Enclosure 1

COLA will be revised as shown in this enclosure. These mark-ups are based on COLA Rev. 6 and replace those provided in RAI 03.07.01-29, Supplement 1 in their entirety.

3H.10 STP 3 & 4 Resolution of Issues with Subtraction Method of Analysis Identified by DNFSB

Figure 3H.6-16: Broadened FRS in E-W (X) Direction at the Top of RSW Pump House Mat (Elevation 18 ft MSL)

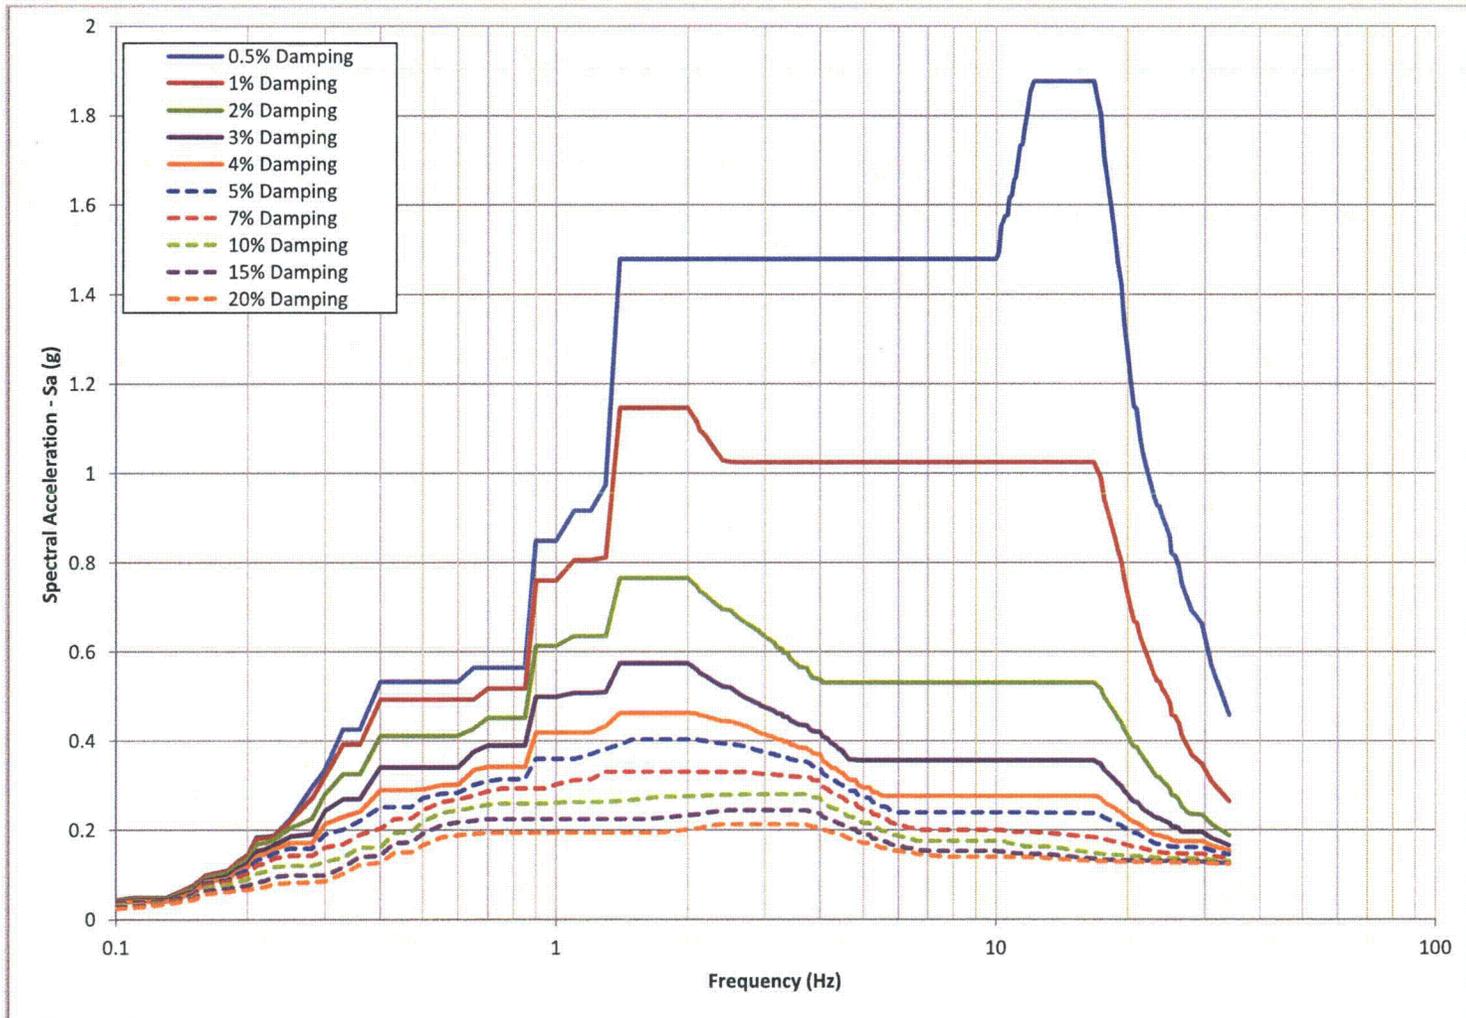
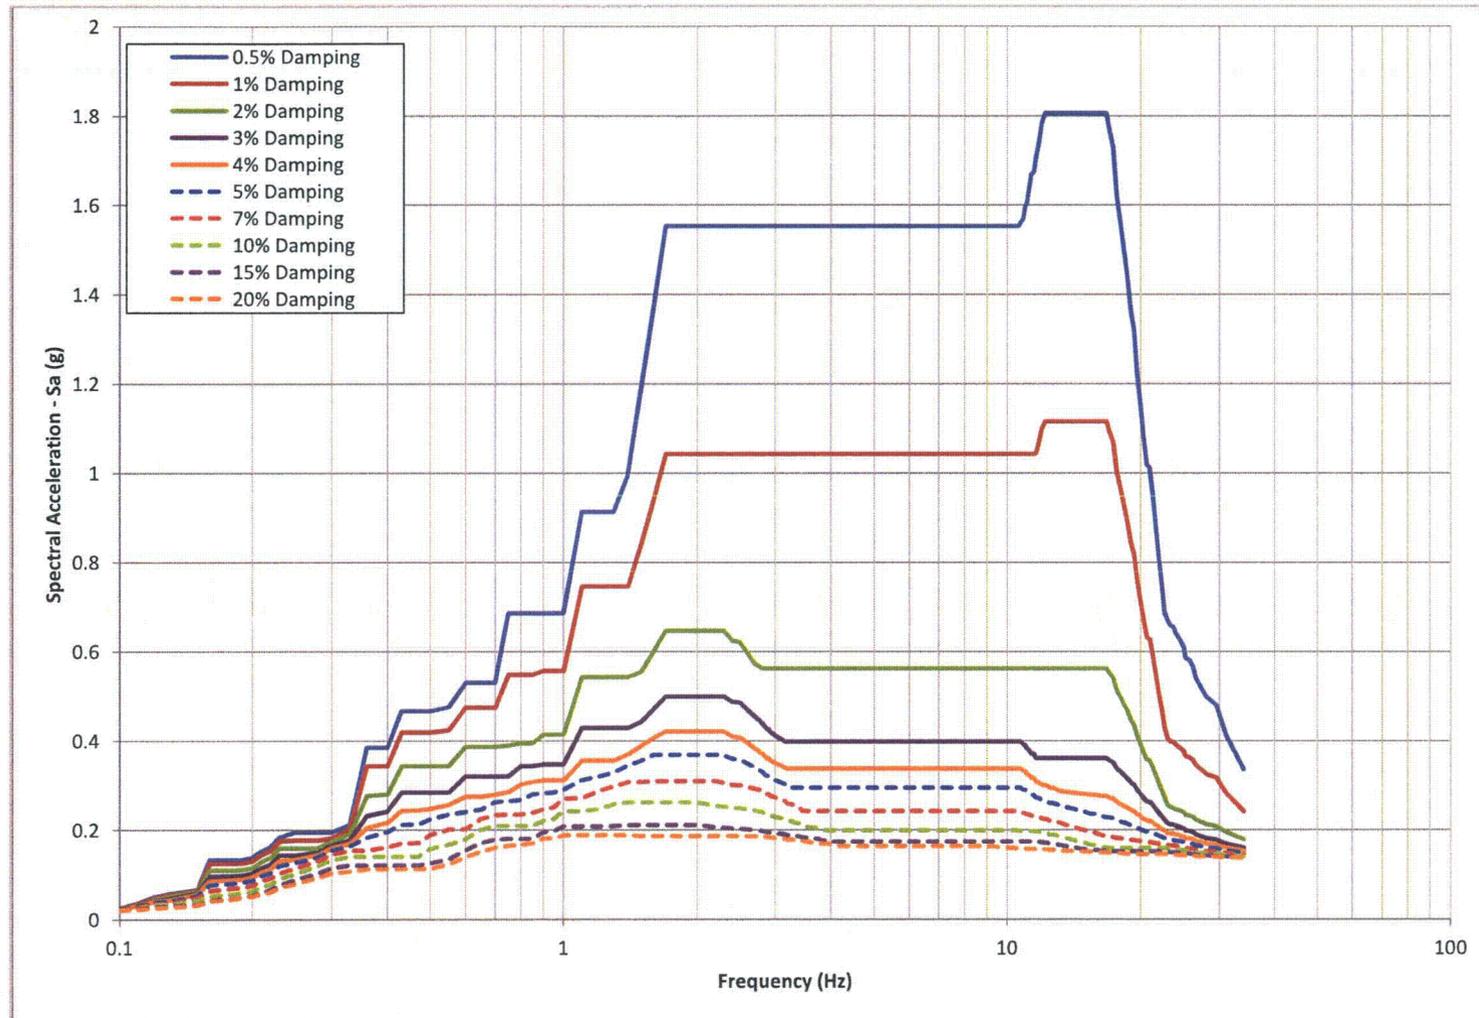
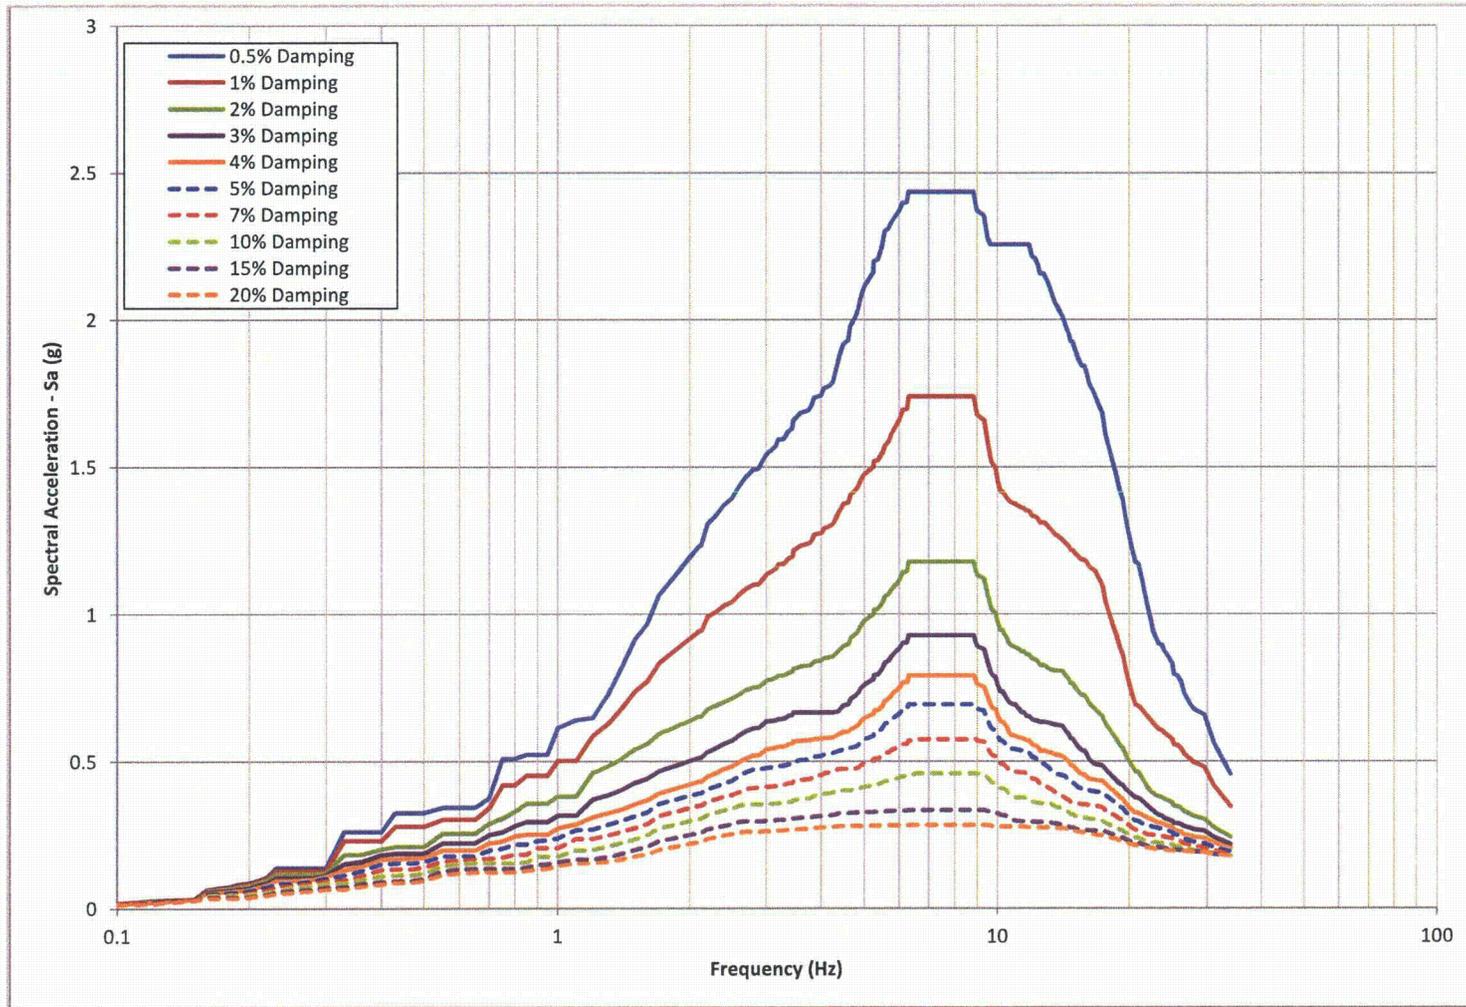
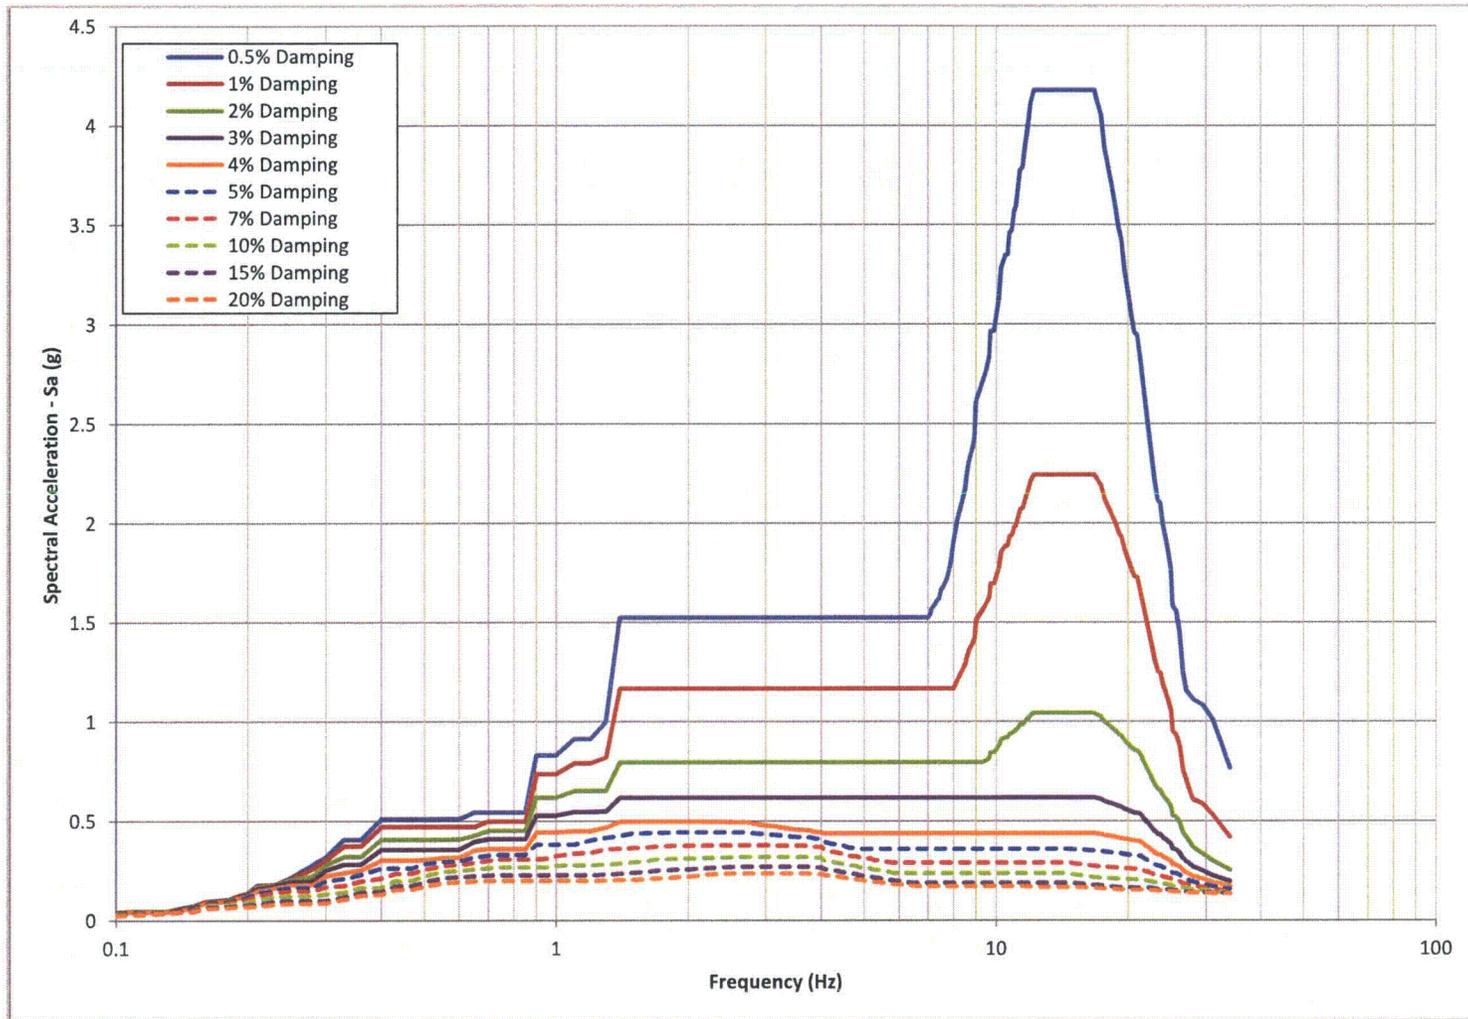
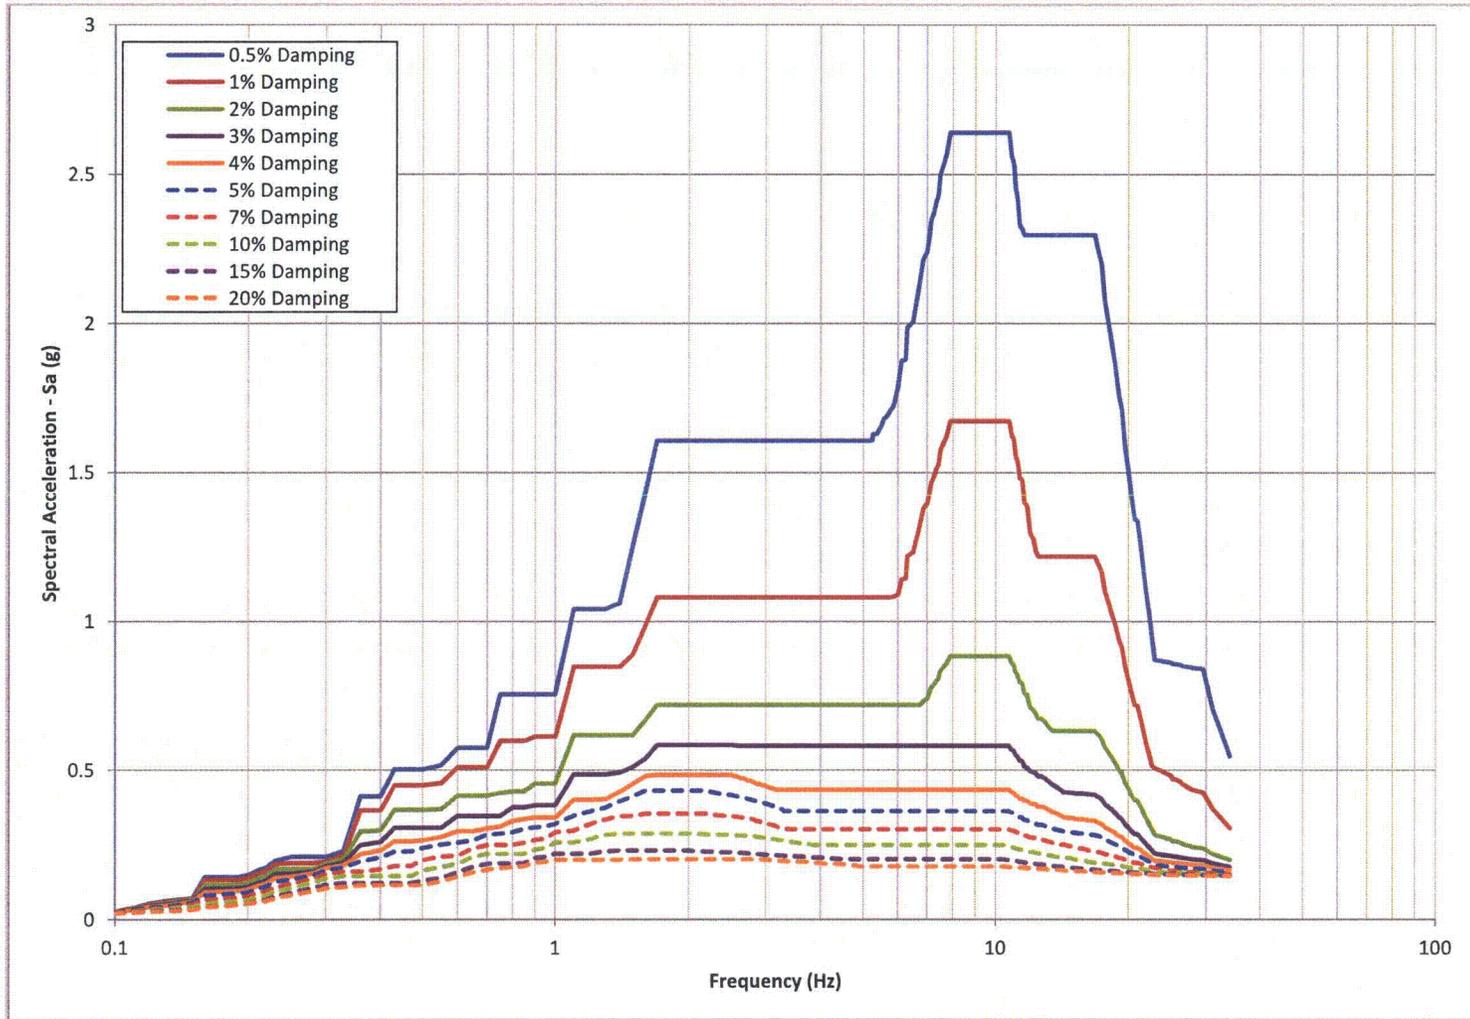
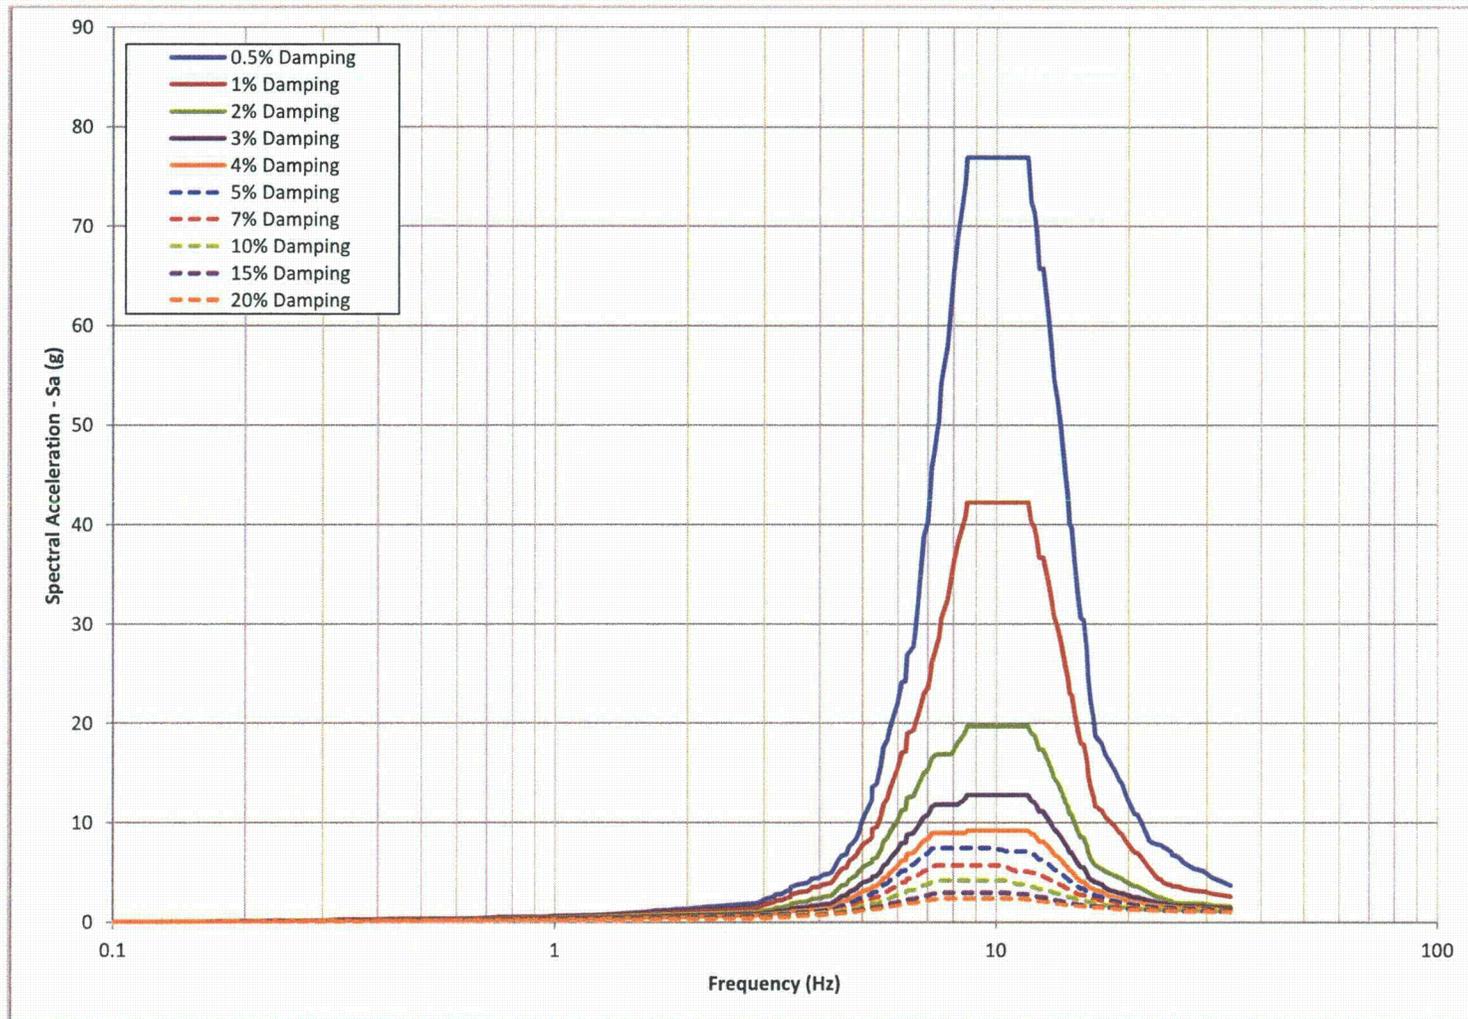
Based on the results of the above refined SSI analyses, and additional structural mesh sensitivity analyses, envelope modification factors were determined for increase of the following in-structure response spectra obtained from the SSI analyses described in Section 3H.6.5.2.4 and 3H.6.5.2.4.1. were modified by multiplying them with the modification factors shown in Table 3H.6-17. Then, the results of the full and empty basin analyses were enveloped.

- Vertical direction spectra at the center of the Pump House Roof
- Vertical direction spectra at the center of the Pump House Operating Floor
- Vertical direction spectra of the Cooling Tower Walls
- Out-of-plane horizontal spectra of the Basin Walls

In response to issues with the subtraction method of analysis identified by the Defense Nuclear Facilities Board (DNFSB) discussed in Section 3H.10, the SSI analysis for the upper bound in-situ soil case was repeated for both full and empty basin cases using the modified subtraction method of analysis. Also, in these analyses the groundwater table was changed to 6 ft below grade. Based on comparison of the resulting response spectra from these analyses to those from the subtraction method of analysis additional modification factors were determined for increase of in-structure response spectra from the subtraction method of analysis to account for the effect of using the modified subtraction method. The product of these modification factors and those described in Section 3H.6.5.2.4.2 as shown in Table 3H.6-17 were used to increase the in-structure response spectra described in Sections 3H.6.5.2.4 and 3H.6.5.2.4.1. Then, the results of the full and empty basin analyses were enveloped.

The final in-structure response spectra are shown in Figures 3H.6-16 through 3H.6-39.

The final in-structure response spectra are shown in Figures 3H.6-16 through 3H.6-39.
